PG&E Letter DCL-06-075

Response to NRC Request for Additional Information Regarding ASME
Section XI Inservice Inspection Program Relief Request NDE-SLH

**PG&E Response to NRC Request for Additional Information (RAI)
Regarding ASME Section XI Inservice Inspection Program Relief
Request NDE-SLH**

Diagram of DCCP Unit 1 Reactor Vessel Showing the Location of the Lower
Shell to Lower Head Circumferential Weld (Weld No. 10-442) and Also the
Location of the 6 Core Support Lugs
Figure 1

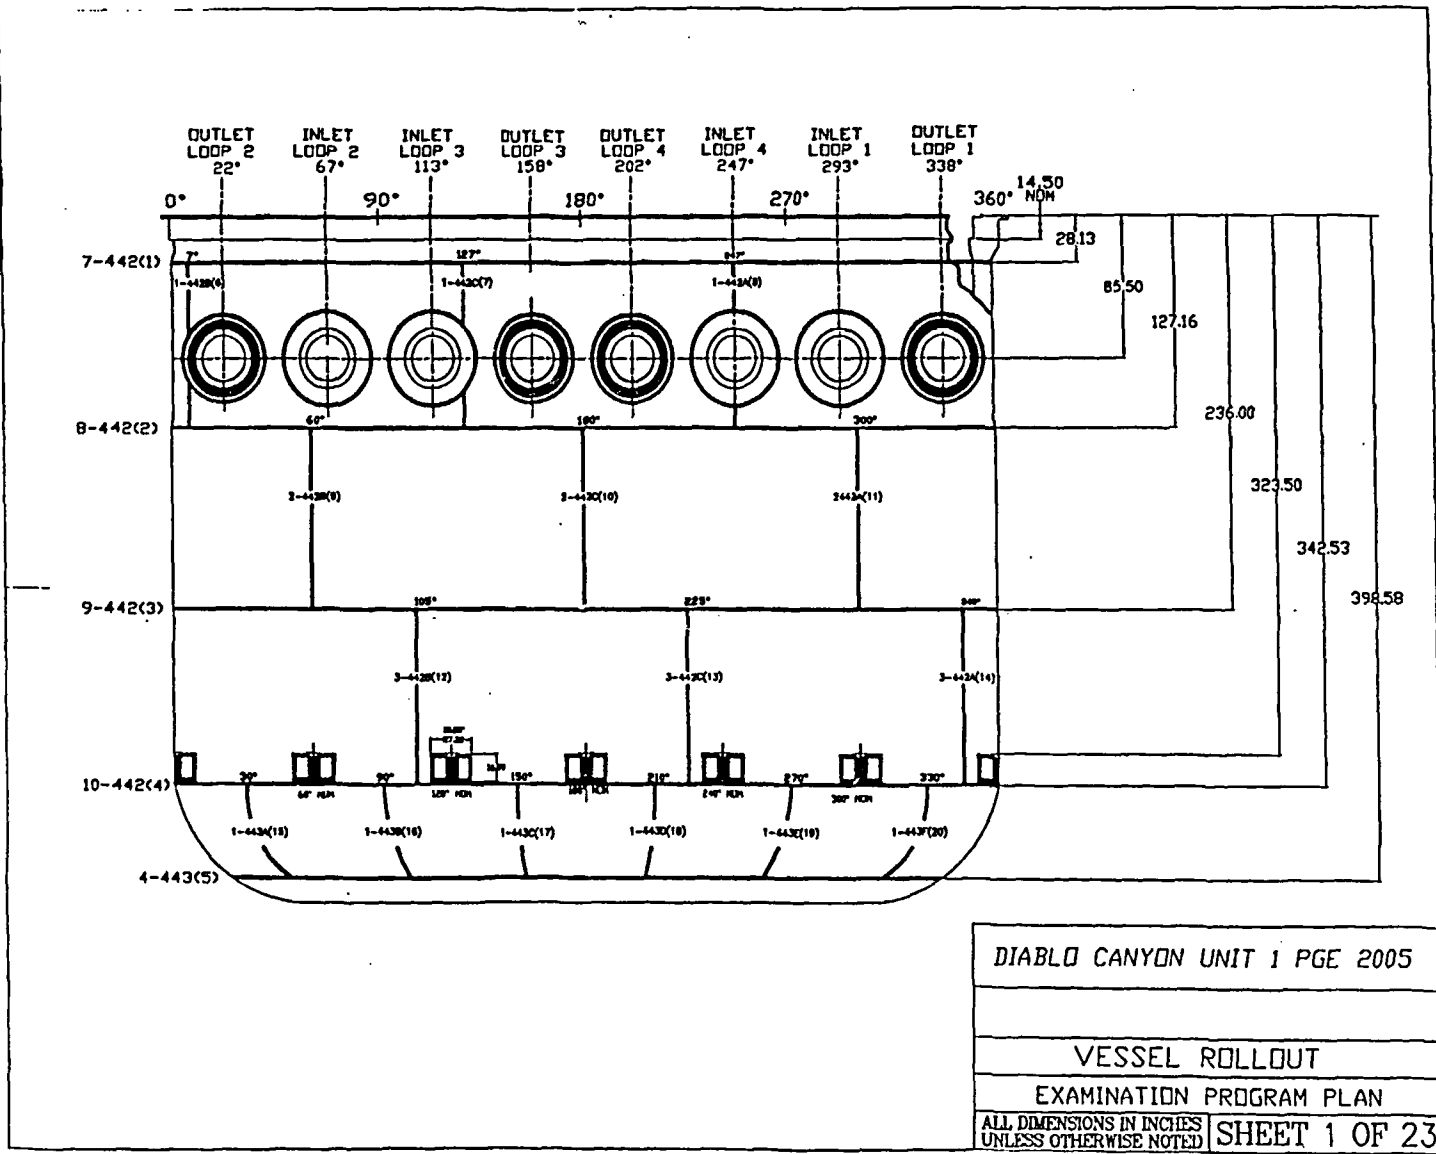
Provide more detail (including drawings) regarding the [NDE] examination. For example, transducers used, direction of scans, and was the ultrasonic examination of the reactor pressure vessel circumferential shell weld [to the bottom] conducted in accordance with techniques qualified by demonstration for Appendix VIII supplements 4 and 6 of the 1995-96 Addenda of ASME Section XI. A good example for this type of relief is VEPCO's letter dated December 12, 2005 for Surry Power Station Unit 2 Relief Request PRT-02, TAC no. MC9224.

The inspection of Diablo Canyon Power Plant (DCPP) Unit 1 reactor vessel lower shell to lower head circumferential weld (Weld No. 10-442) during Unit 1 Refueling Outage 13 (1R13) was conducted using a procedure and techniques qualified by demonstration for 1995 edition/1996 Addenda ASME Section XI Appendix VIII examinations in accordance with Supplements 4 and 6. The examination used a combination of 45 degree angle search units with shear and longitudinal wave propagation and 30 mm or greater focal depths. The sound beams from these transducers were directed in four orthogonal directions parallel and perpendicular to the weld in as close proximity to the six core support lugs as the inspection device and transducer sled would allow. Figures 1, 2, and 3 depict the location of this weld in the reactor vessel, the scanning limitations for parallel and perpendicular scans below the core support lugs, and in between the lugs respectively.

The physical size of the transducer sled limited the approach to the core support lugs without hazarding the assembly and causing damage and loose parts concerns. Calculation of the weld and volume coverage afforded by each set of transducers by the data analysts resulted in a combined coverage of 75.36 percent. Table 1 provides a breakdown of percent coverage of the required examination volume by scan direction and transducers. This coverage is within one percent of the coverage as detailed in the Surry Power Station Unit 2 Relief Request PRT-02. The Surry Power Station Unit 2 reactor vessel has four core support lugs, as opposed to the DCPP Unit 1 reactor vessel, which has six lugs.
